**BEFORE THE HEARING COMMISSIONER
APPOINTED BY THE SELWYN DISTRICT COUNCIL**

IN THE MATTER Private Plan Change Request 80
OF

STATEMENT OF EVIDENCE OF BRONWYN ELIZABETH FAULKNER

- 6 I have I have been asked by the Selwyn District Council (SDC) to carry out a peer review of the *Urban Design, Landscape and Visual Impact Assessment (the Assessment)* provided as Appendix C1 of the application for Plan Change 80 (PC80). My review also considered the Applicant's responses to the Requests for Further Information and the submissions received.
- 7 My review is restricted to the landscape and visual aspects of the Assessment and proposal and I do not comment on urban form or urban design matters.
- 8 In preparing this statement of evidence I have reviewed the following documents:

TWO CHAIN ROAD FRONTAGE - TYPICAL SECTION

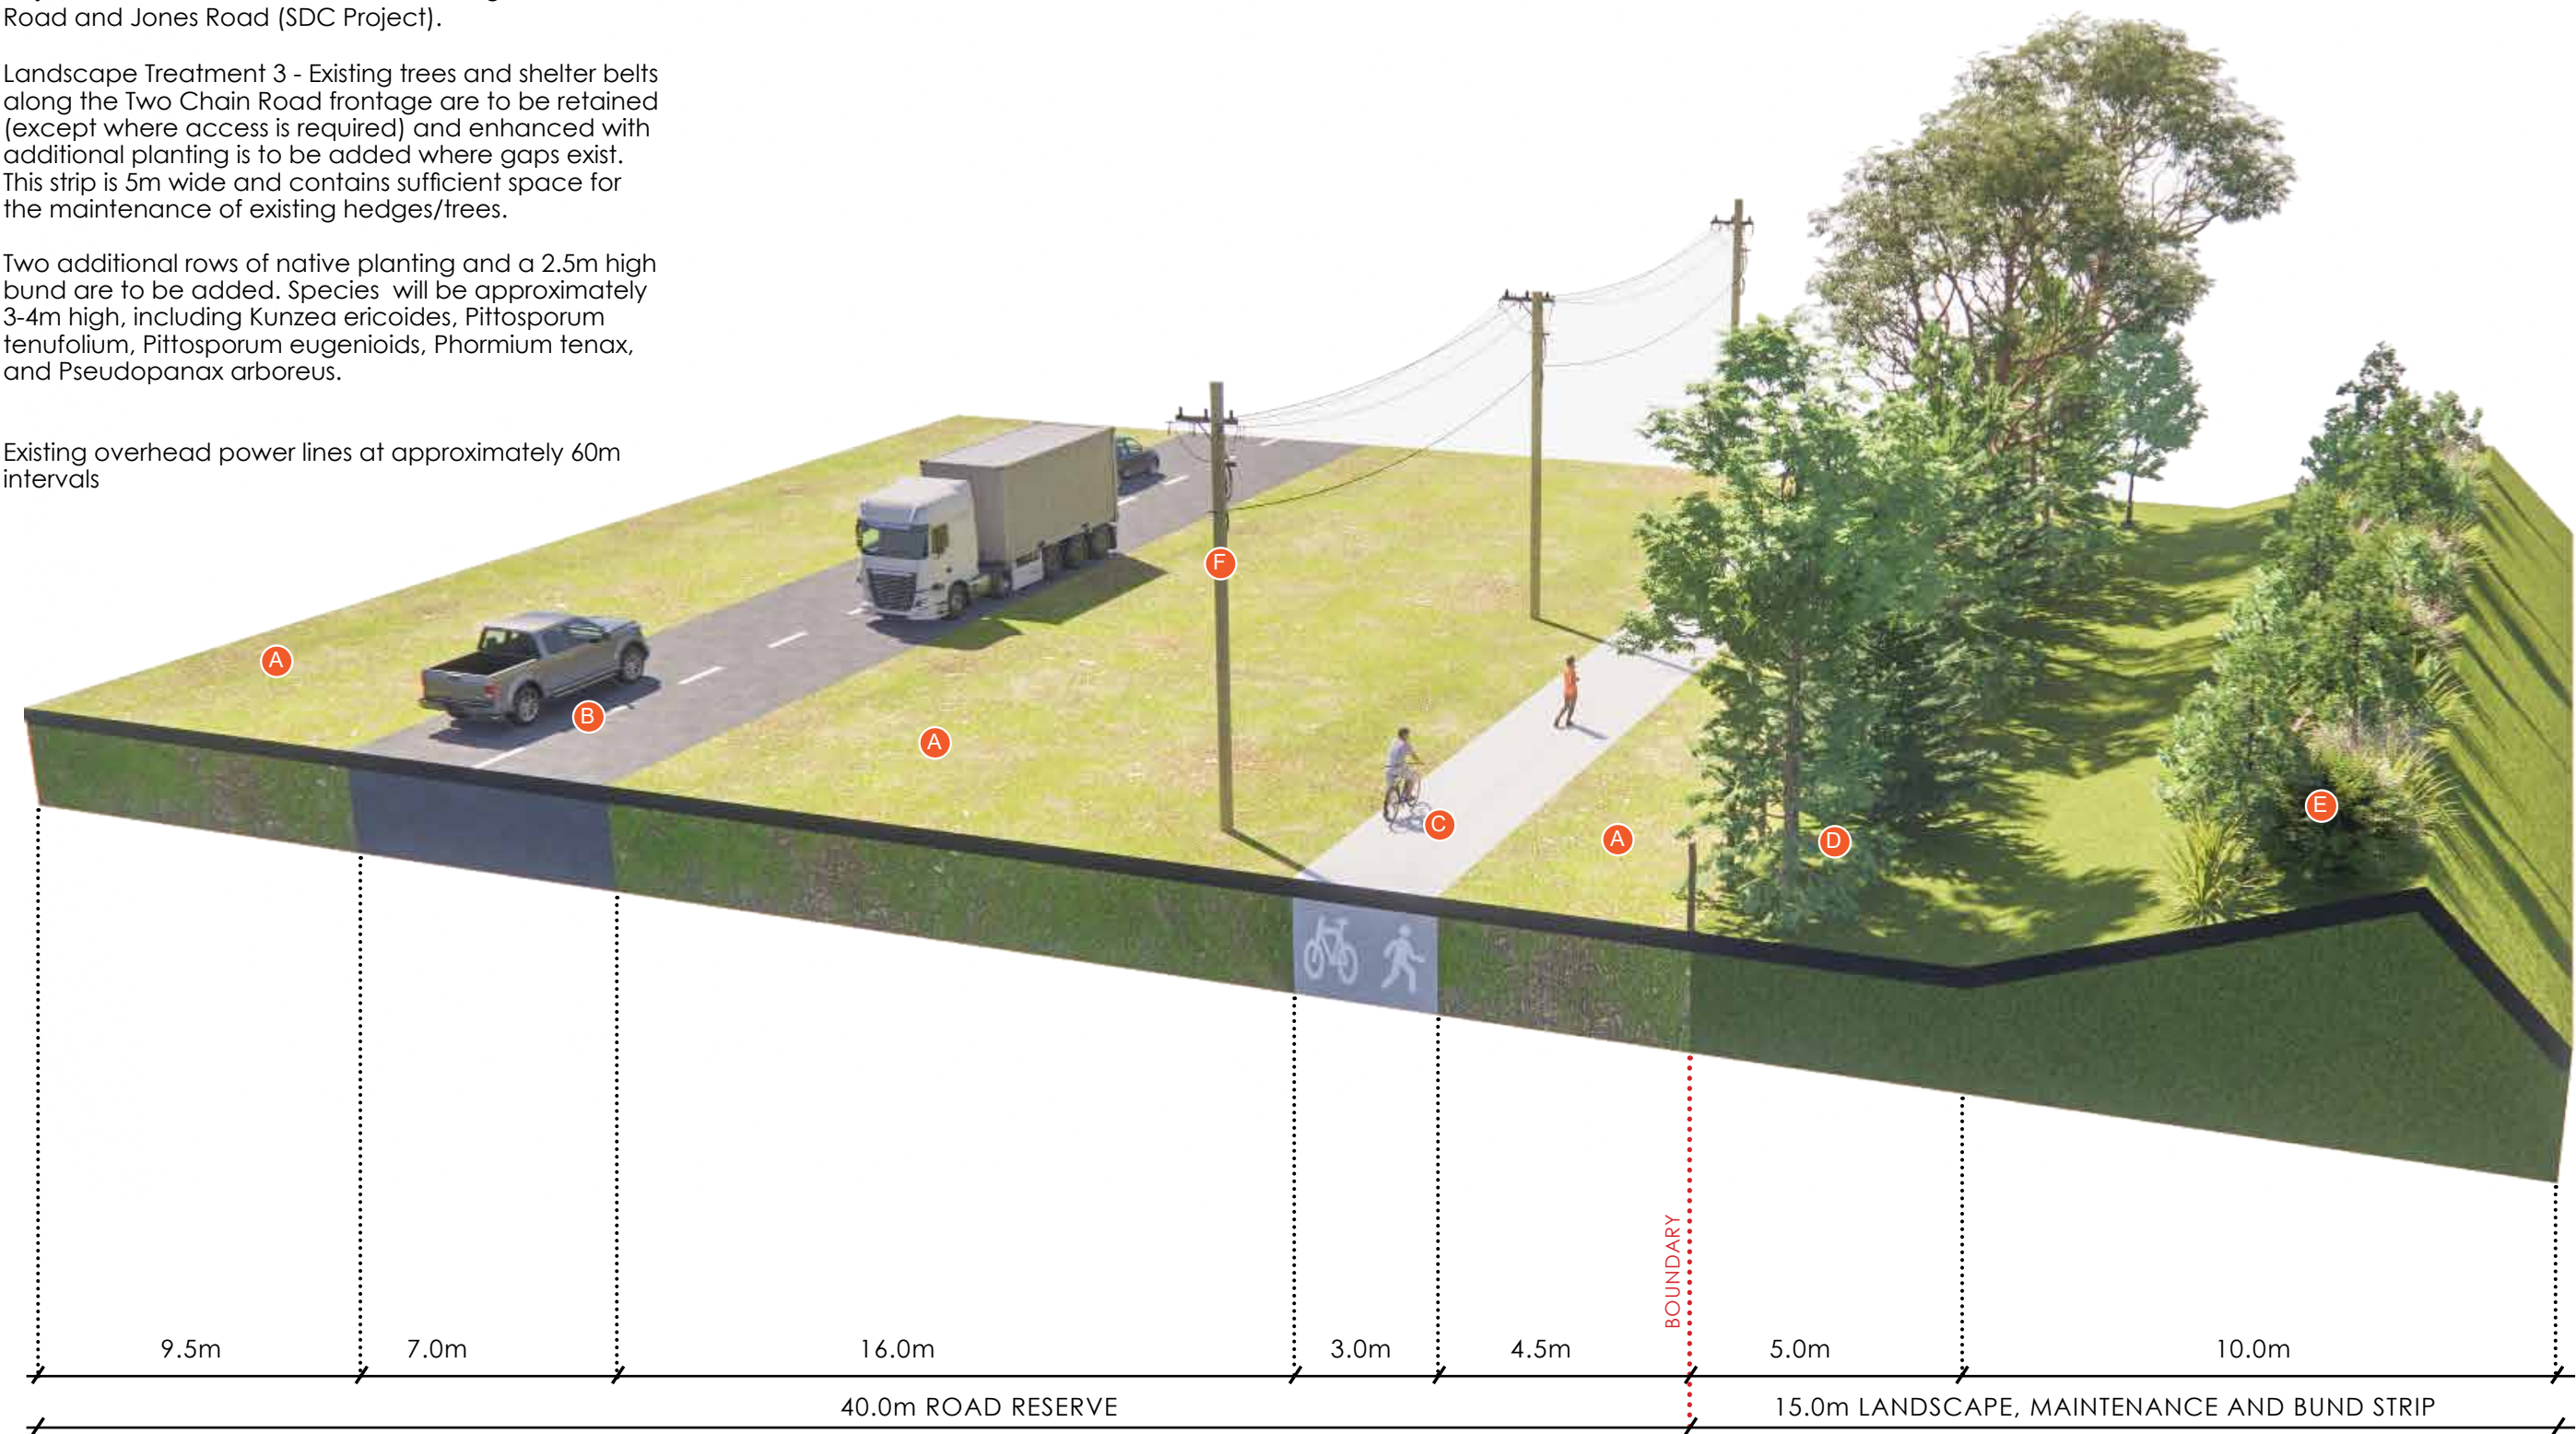
- 40 In the amended Typical Section a 5.0m wide strip is shown to contain the existing trees and *sufficient space for the maintenance of the existing trees/hedges*. Given the species and size of the existing trees, I anticipate that maintenance would involve regular trimming to manage the width of the tree canopy. I question whether the 5.0m width in the Typical Section is sufficient to accommodate both the existing trees and access for a mechanical hedge trimmer. I therefore recommend that either additional space is required or the bund be somehow amended to provide suitable access for a hedge trimmer.

- 41 A 15m wide mitigation strip will result in a 55m wide separation between the Two Chain Road property boundaries and the built edge of the Site (combined width of 40m wide road corridor, 15m boundary setback). The mitigation strip will provide two lines of vegetation and a 2.5m high bund which will combine to visually screen views into the Site from Two Chain Road, and also reduce impacts on rural character from activities within the site.

- 59 The submission requests a wider landscaping strip along Two Chain Road. The amended Typical Section shows a 15m wide strip to accommodate the existing trees, a bund and a secondary row of planting. I consider the amended Typical Section improves the effectiveness of the originally proposed mitigation.

- (b) Revise the Typical Section to demonstrate how the width of the existing trees and access for a mechanical hedge trimmer can be accommodated.
